**MODIFICATION REQUEST TO CONCEPT
APPROVAL AND STATE SIGNIFICANT
DEVELOPMENT ASSESSMENT REPORT:**

**Concept Approval MOD 9
SSD Application for Block 8**

Central Park (former Carlton United Breweries site)

MP 06_0171 MOD 9 and SSD 6092

Figure 4: Comparison between Concept Approval and proposed envelope of Block 8 (Source: Applicant's RtS)

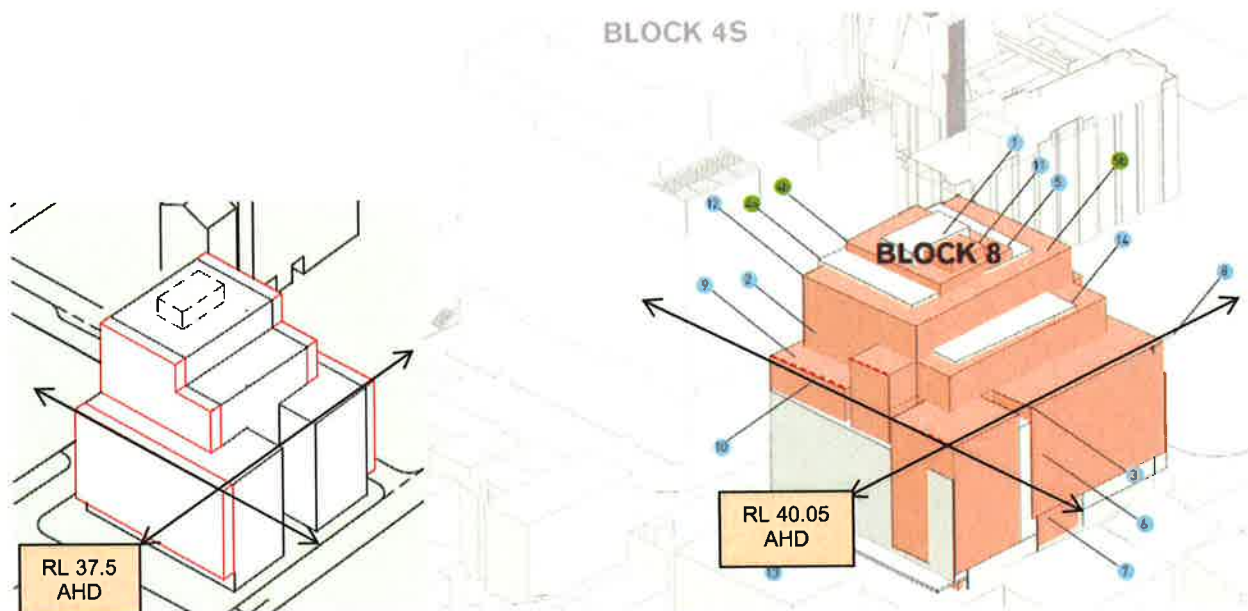
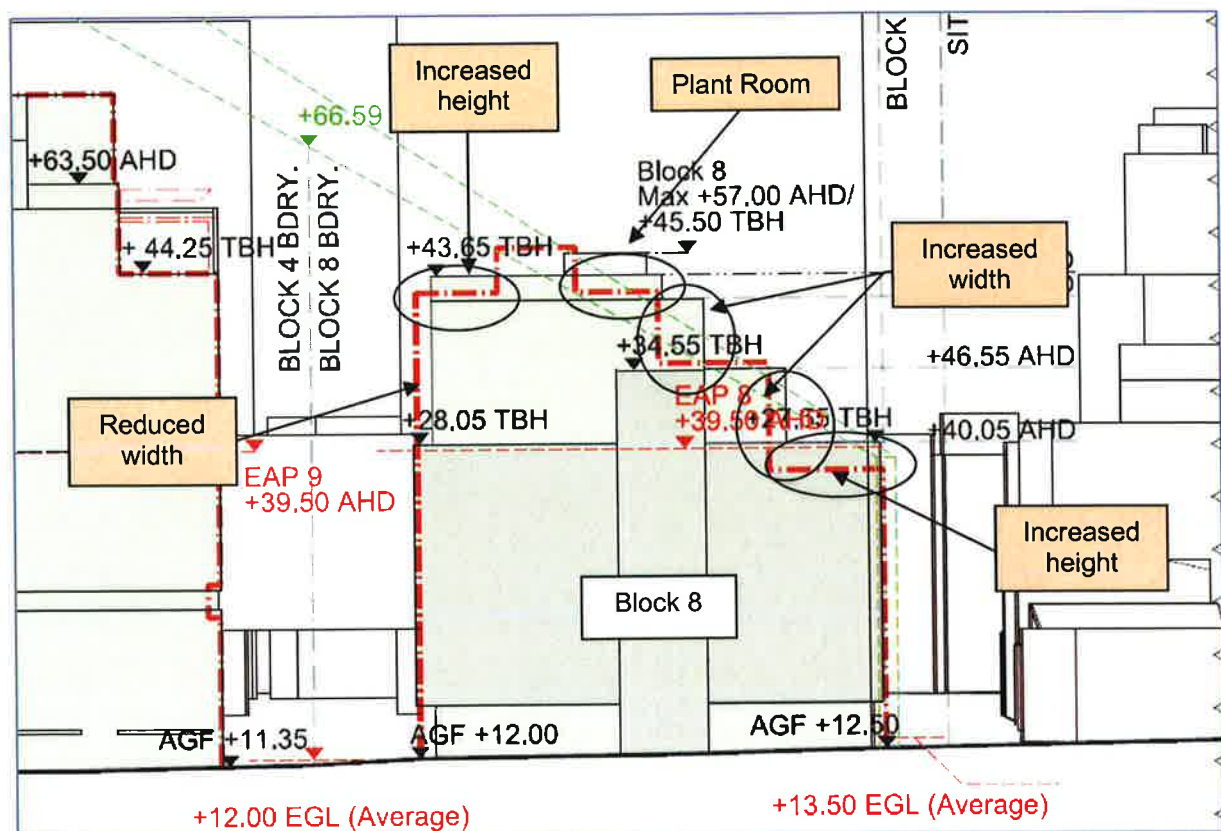
A key concern raised by the Department (and within public submissions) was the additional height and bulk and associated amenity impacts to nearby properties resulting from the modified building envelope when viewed from Abercrombie Street (west) and O'Connor Street (south).

The proposal seeks to both increase the height of the Abercrombie Street and O'Connor Street facade by 2.55 metres and delete the large slot in the façade (a reduced slot is provided to the west), as shown in **Figure 4**.

The Department considers that the scale of the building maintains the transition from Block 4S immediately to the north, by stepping down in height towards O'Connor Street (immediately adjoining to the south is a four storey approved development and other two to three storey buildings) and the varied heights on the Abercrombie Street frontage add visual interest to the roofline. The increase in height of the street edge to Abercrombie and O'Connor Street (notwithstanding the project above the streetwall) provides a consistent reference height to the heritage brewery building and achieves the transition envisaged in the Concept Approval.

Figure 6: Comparison between approved and proposed overshadowing at 9.30am on June 21 as a result of revised Block 8 envelope (Source: Proponent's RtS)

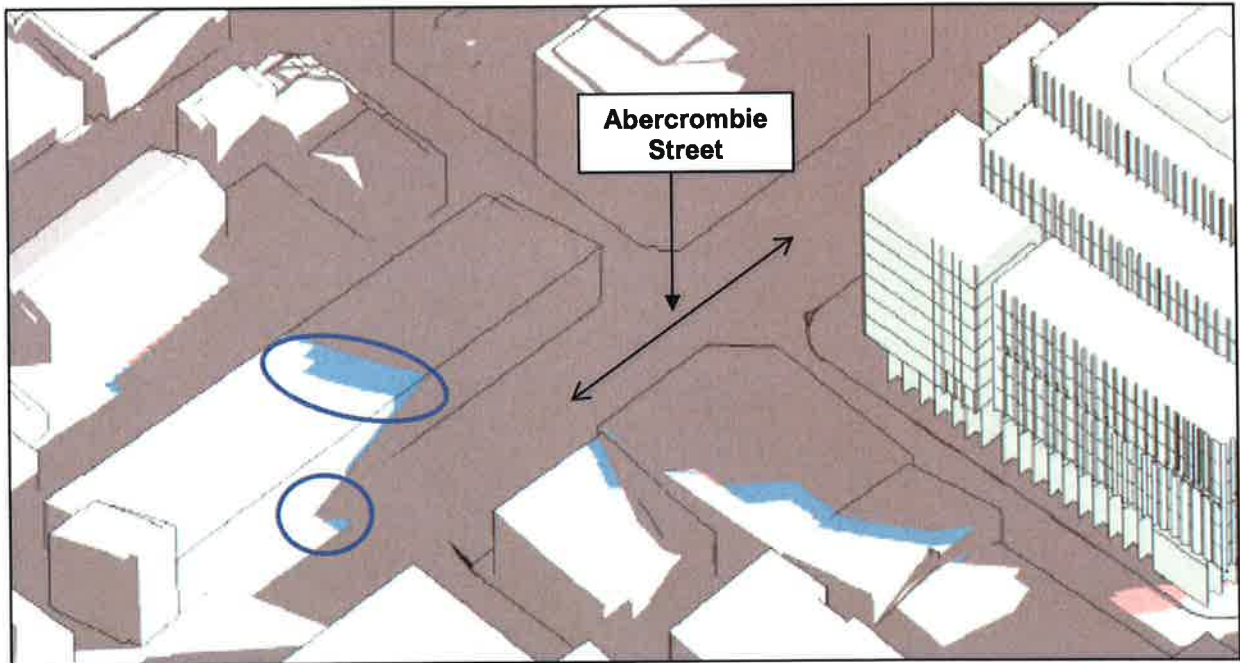
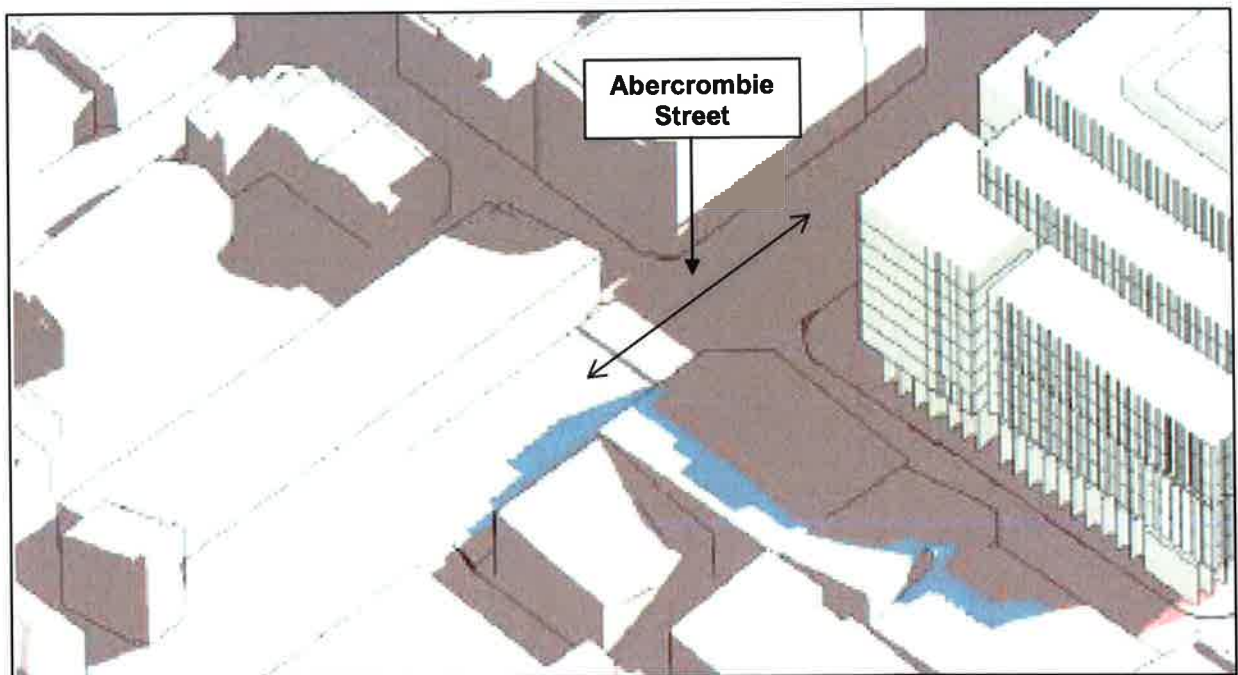
The proposal results in an increase in shadows to neighbouring properties to the west, particularly the eight terraces between 41-57 Abercrombie Street up to 10.30am during midwinter (June 21).

The proponent's shadow analysis indicates that impacts primarily occur on rooftops (**Figure 6**), and that all properties with frontage to Abercrombie Street will retain their existing solar access from 11:00am (**Figure 7**).

The Department accepts that the additional overshadowing primarily occurs over rooftops or along the eastern elevation of Abercrombie Street residences.

Figure 8: Comparison between approved and proposed overshadowing at 1.30pm on June 21 as a result of revised Block 8 envelope (Source: Proponent's RtS)

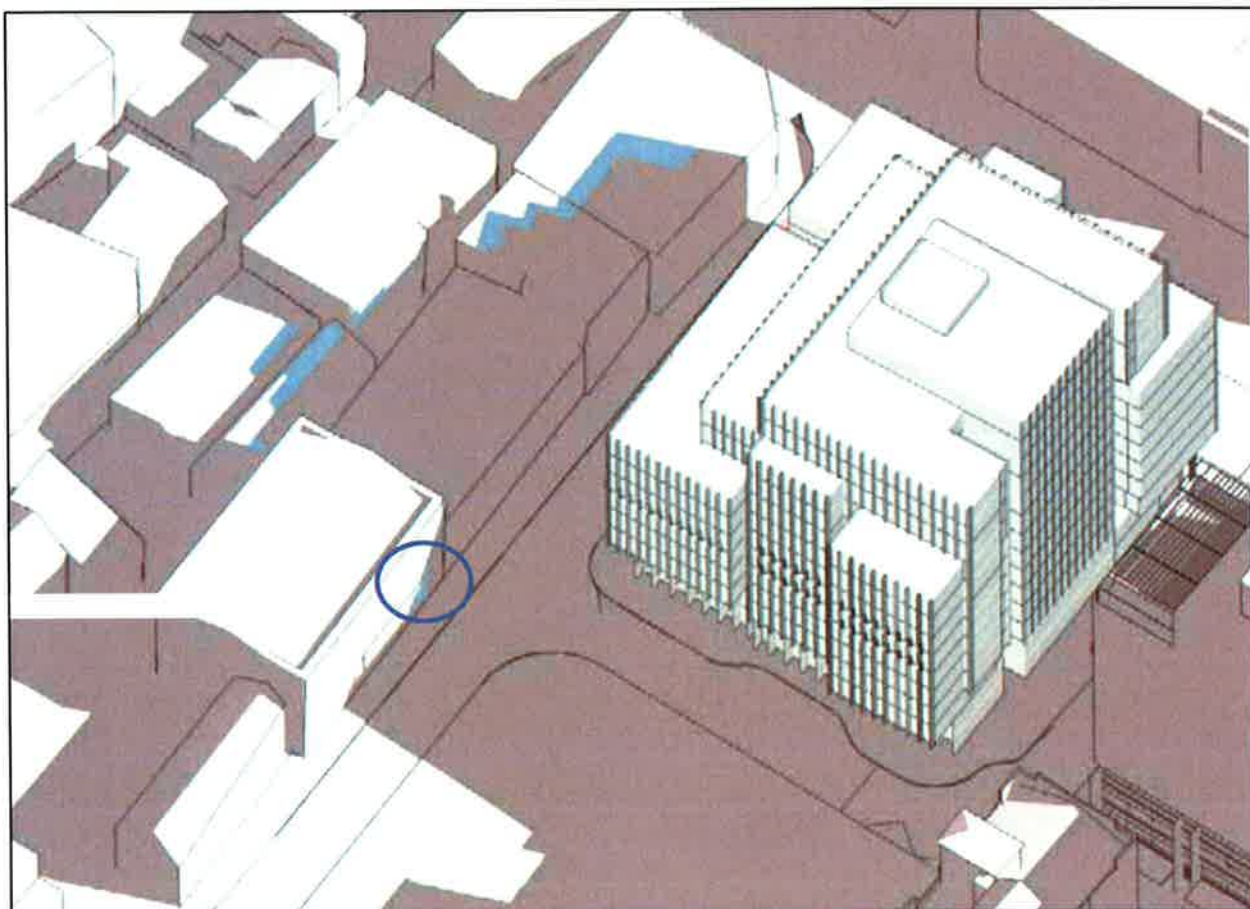
The proposal causes minor additional overshadowing to O'Connor Street properties during mid-winter, between 1.00pm and 2.30pm. The extent of additional overshadowing at 1.30pm is shown in **Figure 8**. The rooftops of buildings also receive additional overshadowing, however this does not impact upon the amenity of these properties.

On this basis, the Department concludes that the overshadowing impact on O'Connor Street properties is acceptable in the context of the site's dense city edge urban location.

Figure 9: Comparison between approved (grey shadow) and proposed overshadowing (light blue shading) at 12.30pm on June 21 on residential area of Dick Street (Source: Proponent's RtS)

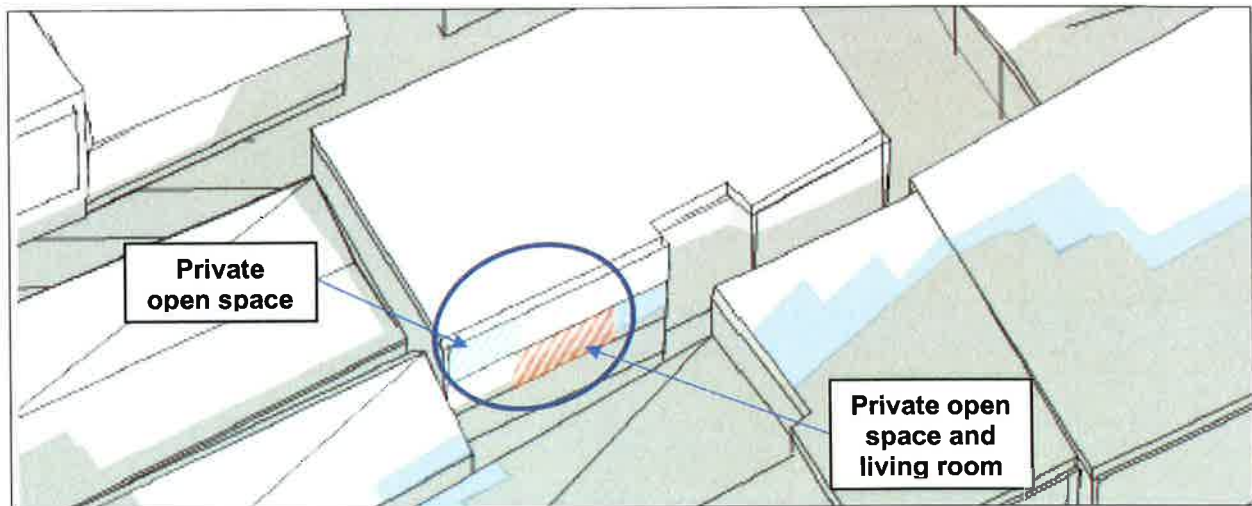
The proposal will also result in minor increases in shadowing to properties in Dick Street, which is located to the south of O'Connor Street and includes a mix of warehouse / residential uses. A public submission was received from a property on Dick Street that contains residential uses above ground level with views towards Block 8 (**Figure 9**).

The residential component of the property at Dick Street maintains 3 hours of solar access between the hours of 9.30am and after 12.30pm, mid-winter, which is acceptable noting that this exceeds the City of Sydney Development Control Plan 2012 requirement to achieve a minimum of 2 hours direct sunlight between 9am and 3pm on 21 June.

Figure 10: Building separation between Block 4S (top) and Block 8 (bottom) envelope (Source: Proponent's RtS)

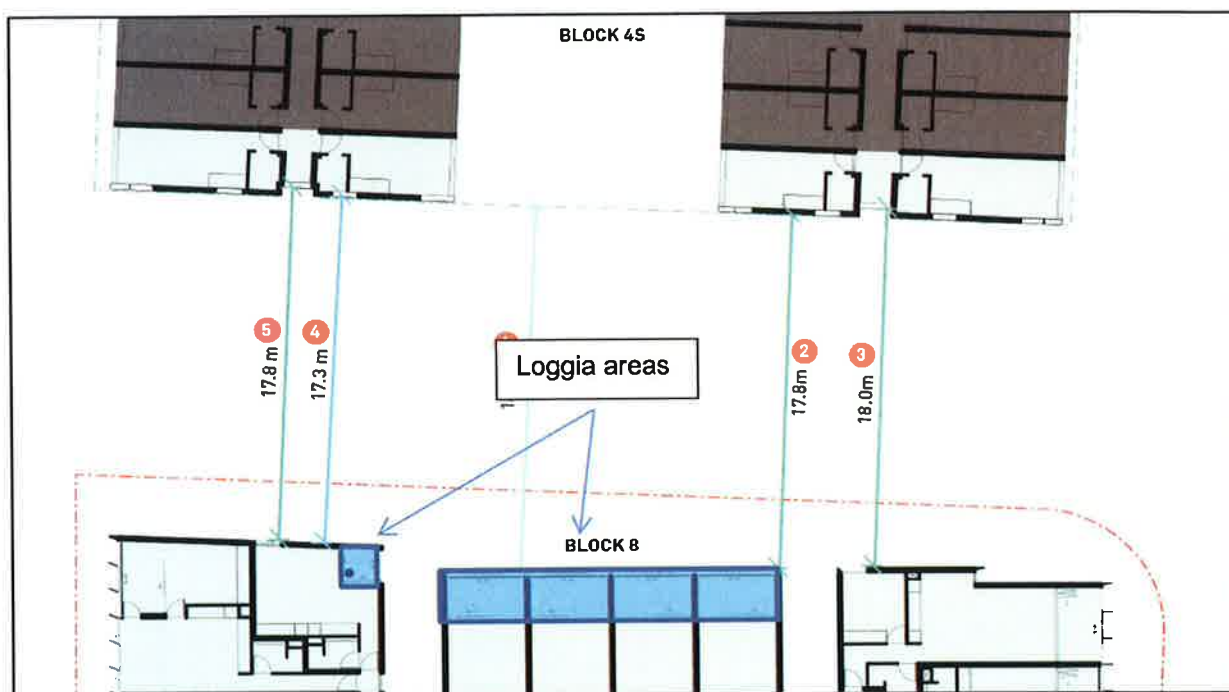
The proposal seeks to reduce the minimum building separation between Block 4S and Block 8 from 18 metres to a minimum of 17.3 metres (**Figure 10**) at Level 1 to 7, which does not meet the Residential Flat Design Code (RFDC) recommended separation distance of 18 metres.

Although the building separation does not strictly meet the RFDC recommendation, the variation of 0.7 metres is minor and the northern façade of Block 8 is opposed by either small windows on Block 4S or are offset to the windows in Block 8 (i.e. windows and open space areas are not directly opposite each other), which will provide adequate privacy between units.

The Department concludes that the proposed 0.7 metre reduction in separation distance is therefore acceptable.

Figure 12: Approved (left) and proposed (right) public domain and access arrangements for Block 4S and 8 with a new access driveway for Block 8 (Source: Proponent's application)

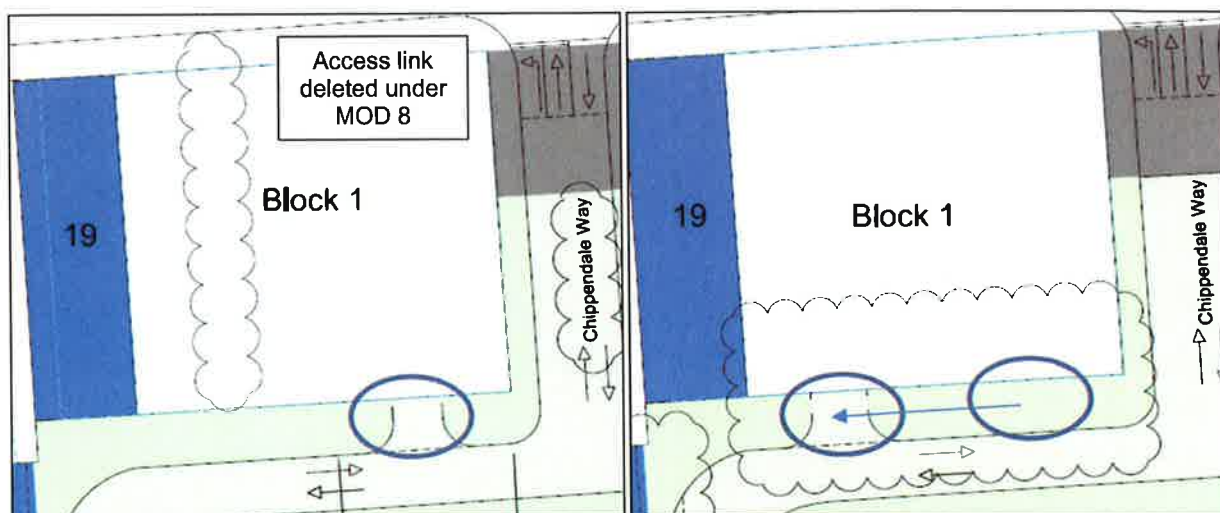
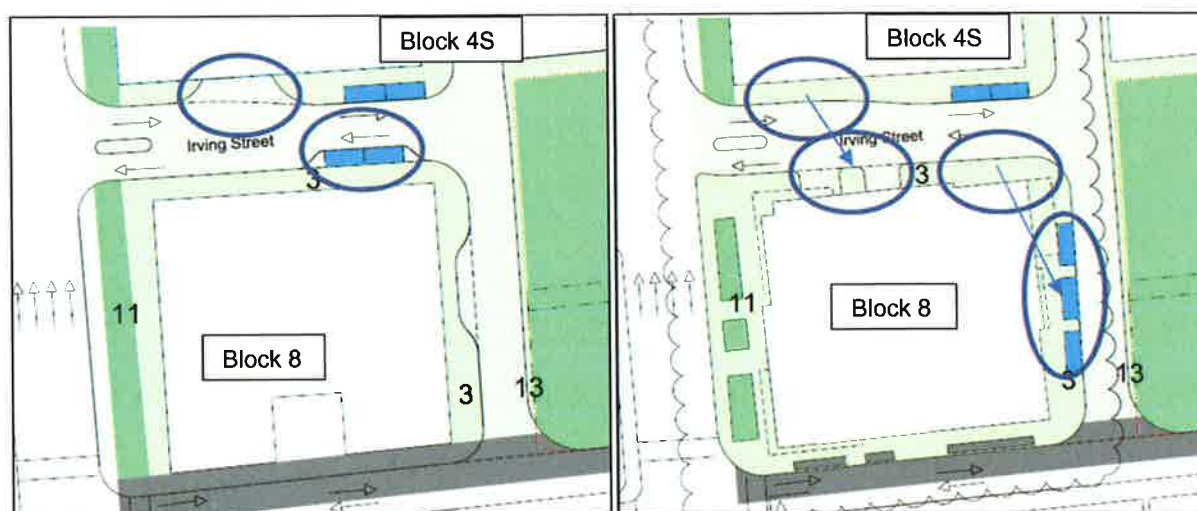
The proponent seeks to amend car park access arrangements for Block 1 and 4S (**Figure 11**) and the public domain and car park access arrangements for Block 8 (**Figure 12**).

- Block 1 – relocation of the car park entrance further west, increasing the distance from Chippendale Way (**Figure 11**);
- Block 4S – deletion of the car parking entrance off Irving Street as access is now provided through the combined basements under Blocks 1 and 4N (**Figure 12**); and
- Block 8 – provision of vehicular access off Irving Street as a result of the deletion of the combined basement between Block 4S and 8. Subsequent relocation and increase in on-street parking to the eastern frontage of Block 8 (**Figure 12**).

Council and RMS raised no concerns with the amendments. Council also acknowledge that the proposal is consistent with RMS requirements for separation distances and maintains acceptable sightlines.

The Department notes the majority of the amendments are a result of new or amended car parking arrangements following the recent approval of the separation of the combined Block 1, 4N and 4S basement from Block 8. The Department supports the concept of the relocation of the access to Block 1 further from the intersection of Chippendale Way. This design will be assessed in detail in the current SSD application on exhibition.

Figure 13: Public domain treatments surrounding Block 8 (Source: Proponent's RtS)

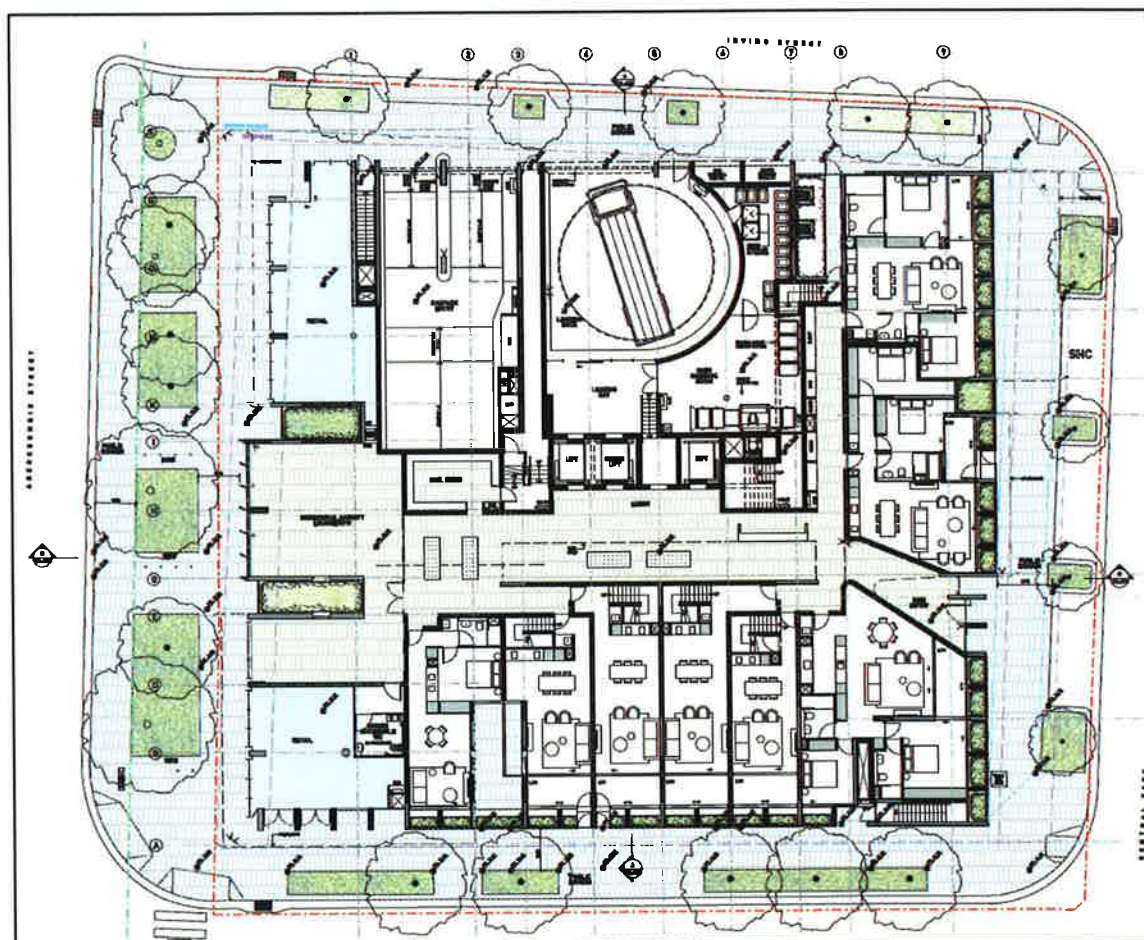
Council raised concerns that the overhang of the building from Level 1 and above would impact on proposed street trees provided within the public domain, particularly those on the corner of Central Park Avenue and Irving Street. Council recommended the deletion of a street tree at this location. The Department recommends Condition B6 to require Council's endorsement of the public domain / landscape plans prior to the relevant Construction Certificate for above ground works. This will enable further consideration of street tree placement in the detailed design.

The Department is of the view that the public domain provides a quality interface for pedestrians, retail visitors and occupiers of the building, is consistent with adjoining areas, and provides through site access without any impediments.

The Department concludes that the public domain treatments are suitable and will complement the existing public domain areas within the Central Park and also provide a transition to areas to the south.
